- SHOP DRAWINGS WERE DEVELOPED USING THE FOLLOWING RESOURCES FOR THE CONTRACT: STATE OF VERMONT AGENCY OF TRANSPORTATION, CONTRACT PLANS FOR: CABOT - DANVILLE FEGC F 028-3(26) C/I U.S. ROUTE 2, SHEETS 48 TO 53 OF 250 DATED 13-OCT-2010, WITH REVISION DATE OF NONE. SHEETS 101 TO 106 OF 250 DATED 10/25/2010, WITH REVISION DATE OF NONE. SHEETS 108 TO 111 OF 250 DATED 10/25/2010, WITH REVISION DATE OF NONE.

US Route 2
Cabot-Danville, VT
FEGC F 028-3(26) C/I

DESIGNED BY: DTM				PROJECT NAME	U.S. ROUTE 2 OVER EXISTING STREAM	DATE 04/6/11
PROJECT ENGR: LY	2	8/19/11	REV. PER GIA COMMENTS REV. HALF CONNECTOR DETAILS	LOCATION	CABOT-DANVILLE VERMONT	CONTRACT NO. RE-15053
CHECKED BY: PLA/EEH	1	7/19/11	REV. PER GIA COMMENTS	OWNER	VTAOT	DRAWING NO. 1 OF 7
REV.	DATE		DESCRIPTION	DRAWING COVERS	GENERAL NOTES	SCALE AS SHOWN

ITEM 525.33 BRIDGE RAILING - NETC 2 RAIL
 US RT 2 OVER EXISTING STREAM
 TOWN OF CABOT-DANVILLE, VERMONT
 PROJECT NUMBER: F EGC F 028-3(26)C/1

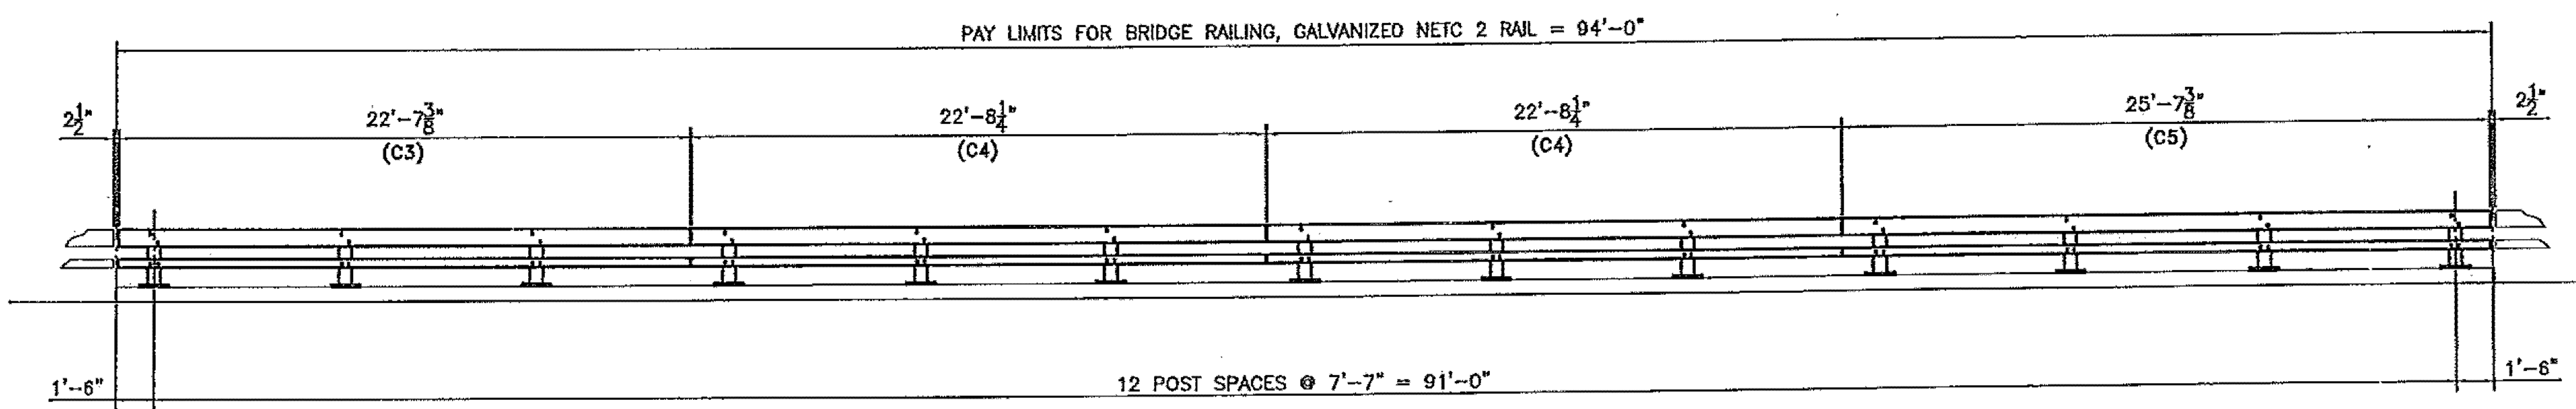
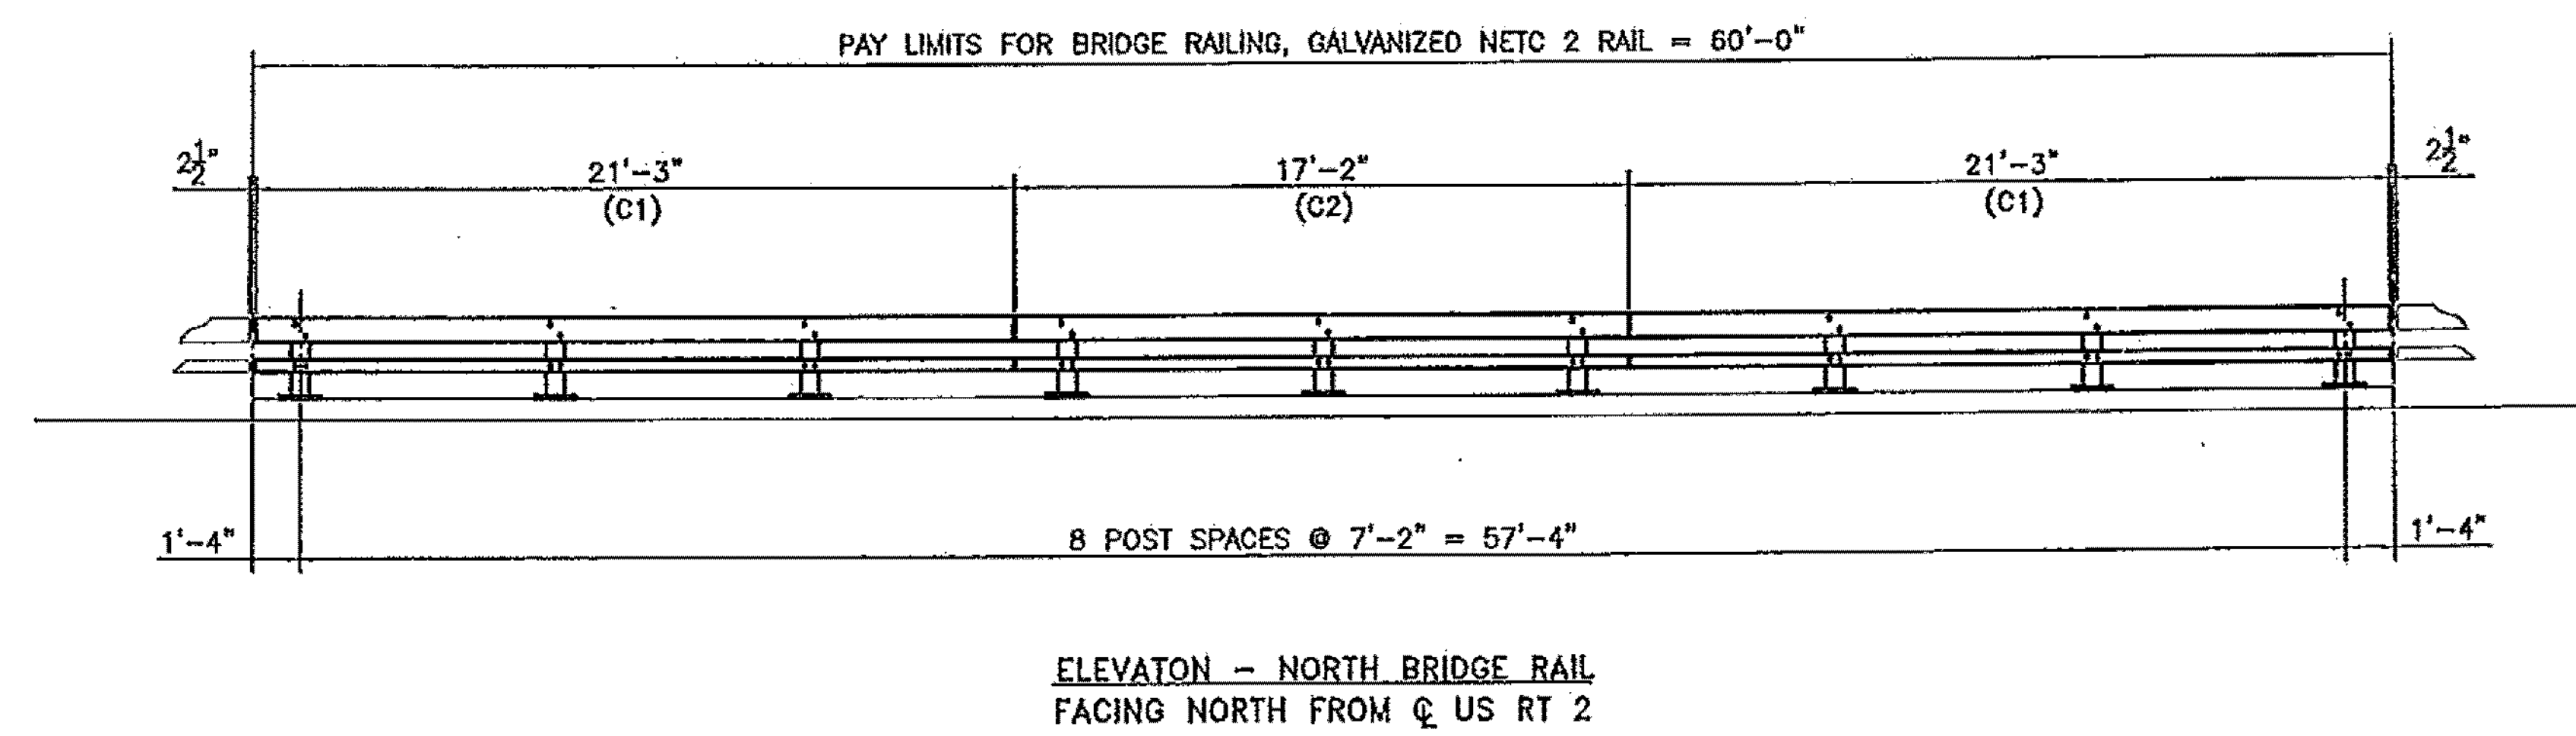
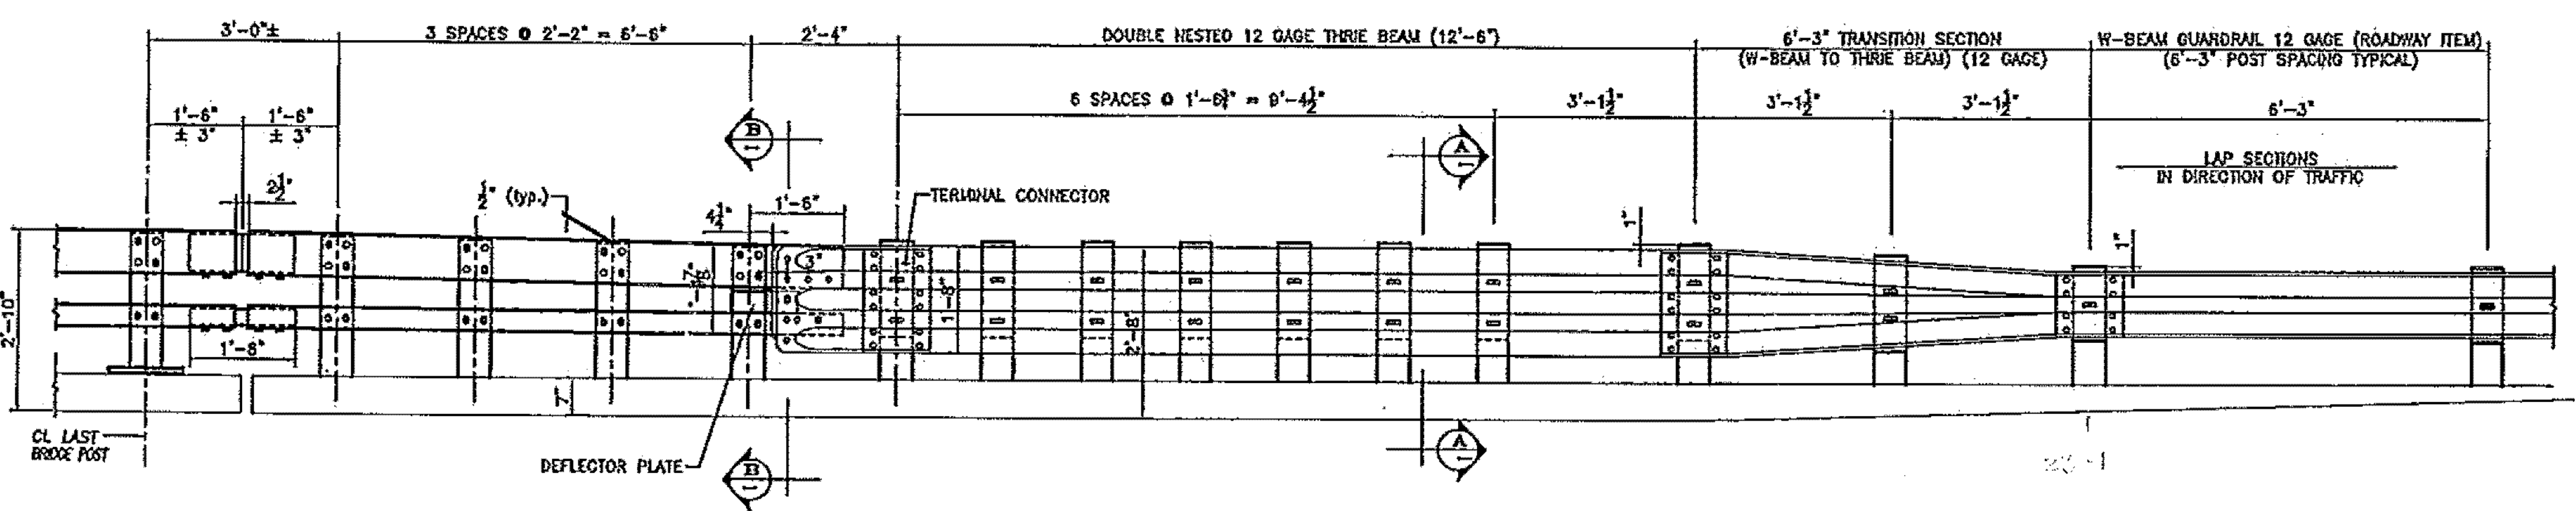
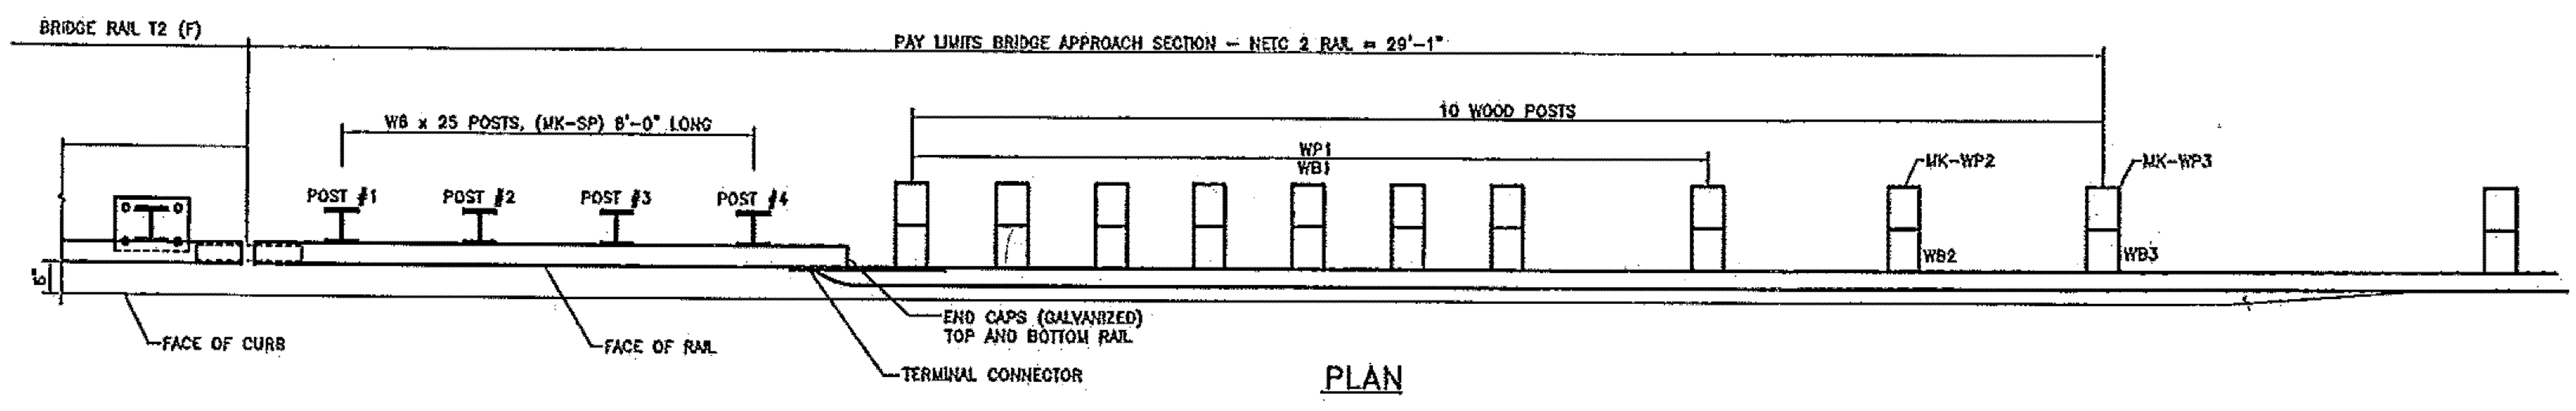
REVISE WITH INITIAL TYPE
(REF. SHIT 2)
